Tierra Del Este Unit Eighty Two

City of El Paso — City Plan Commission — 10/4/2018

SUSU17-00047 — Resubdivision Preliminary

PROPOSED

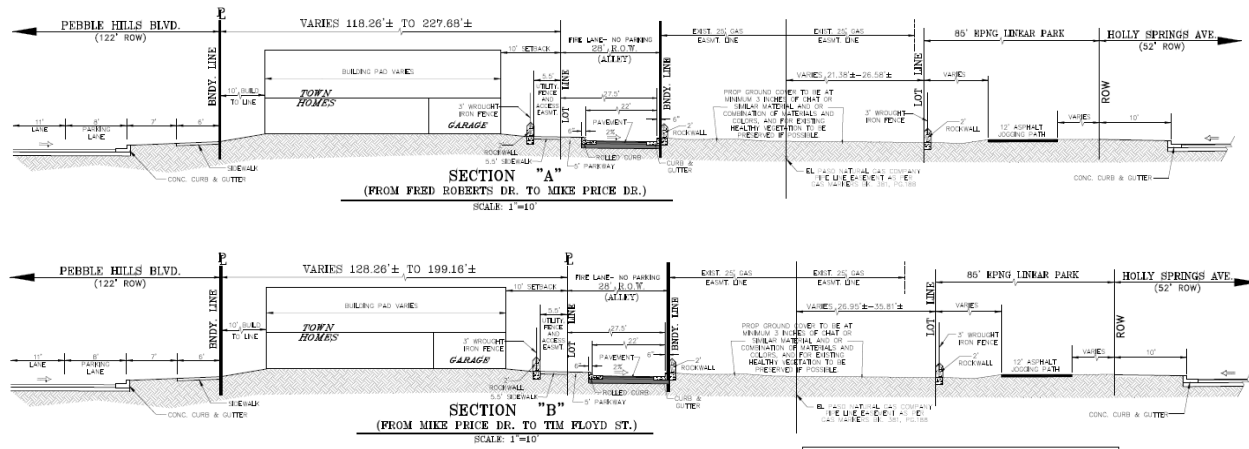
- To allow for an alternative design for the 28' alley which includes a 5' parkway and 22' of pavement.

ESD is good with the revised plat and alternative design that includes the 28' ROW (alley), and the abutting 5.5' utility easement. We also requested that signage be required in the alley per Title 12 indicating that the ROW is a fire lane/tow away zone.

We have reviewed the revised alley cross-section alternative design and have no further comments.

ATTACHMENT 2

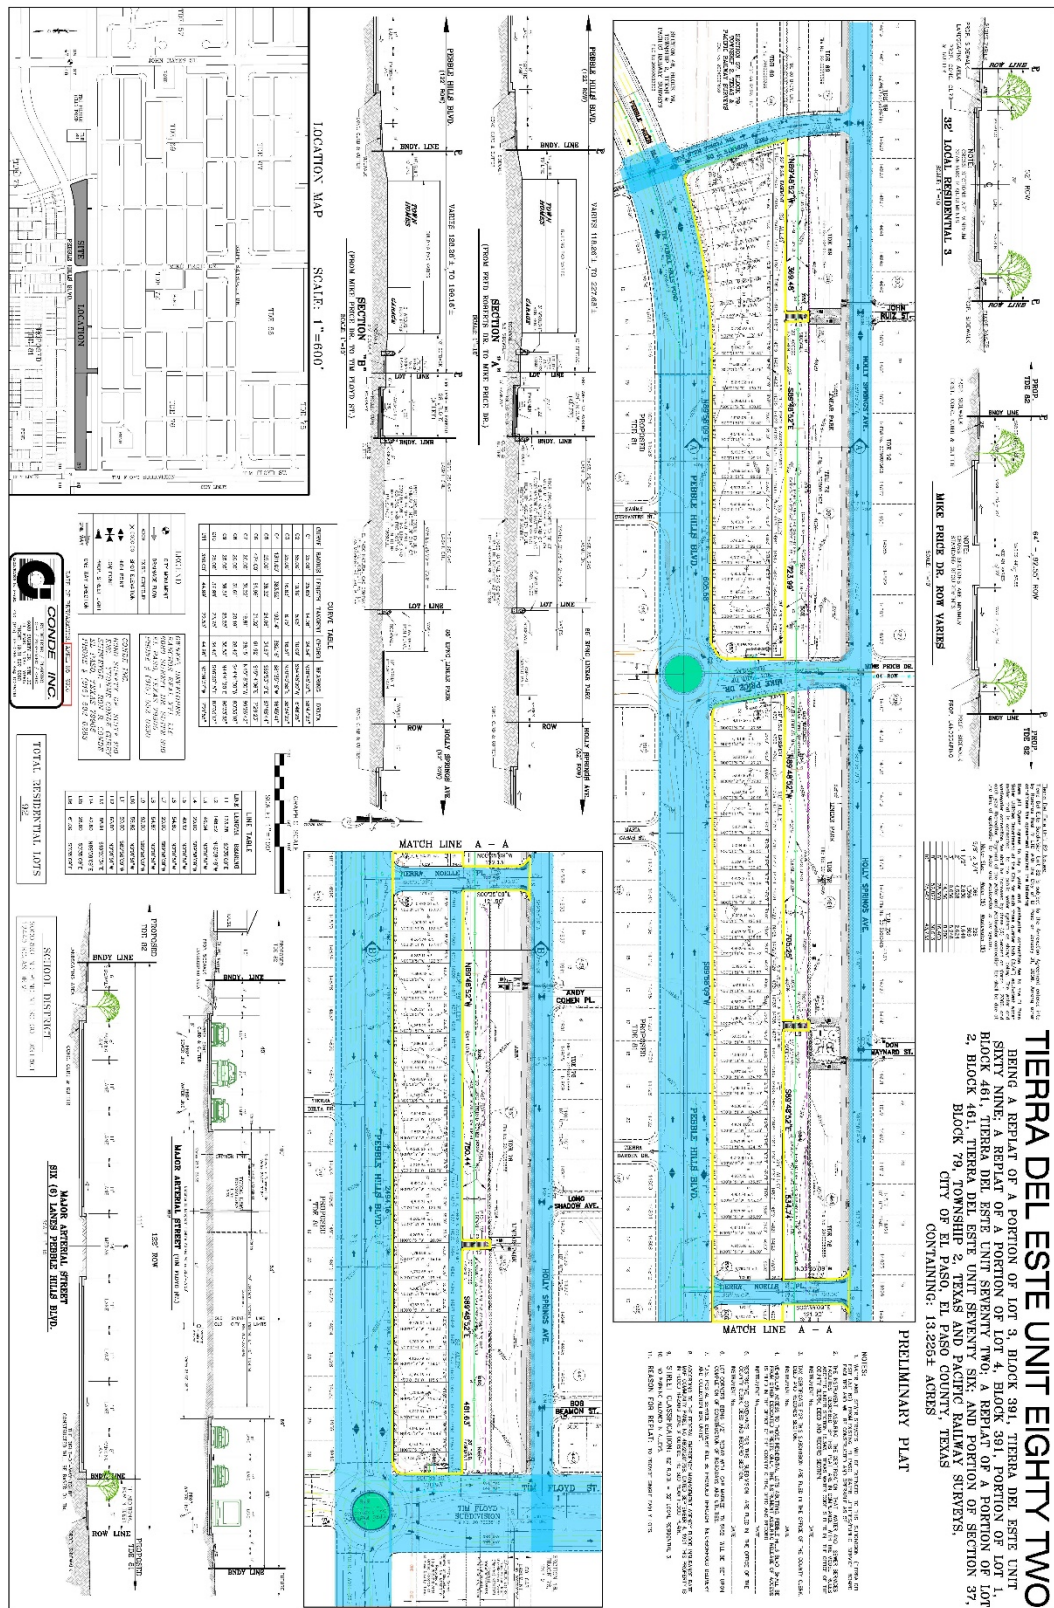
- Submit to the Planning & Inspections Department – Planning Division the following prior to recording of the subdivision:
 - a: Current certificate tax certificate(s)
 - b: Current proof of ownership.
 - c: Release of access document, if applicable.
 - d: Set of restrictive covenants, if applicable.
- Every subdivision shall provide for postal delivery service. The subdivider shall coordinate the installation and construction with the United States Postal Service in determining the type of delivery service for the proposed subdivision. In all cases, the type and location of delivery service shall be subject to the approval of the United States Postal Service.
- Verify and revise the date of preparation on the preliminary plat.

1. As per Tierra Del Este Unit 69, 72, & 76 Drainage Plans, the subject subdivision is to discharge into their proposed ponds; all downstream storm water management facilities should be in place prior to development of this development.
2. Show the drainage flow pattern within the alleys.
3. Show and label designated ponding destination(s).

The existing stub-outs are available for main extensions. The easements to accommodate the extensions are to be labeled PSB Easements instead of Utility Easements. A rock wall shall be constructed at the easement line that is within the lot.
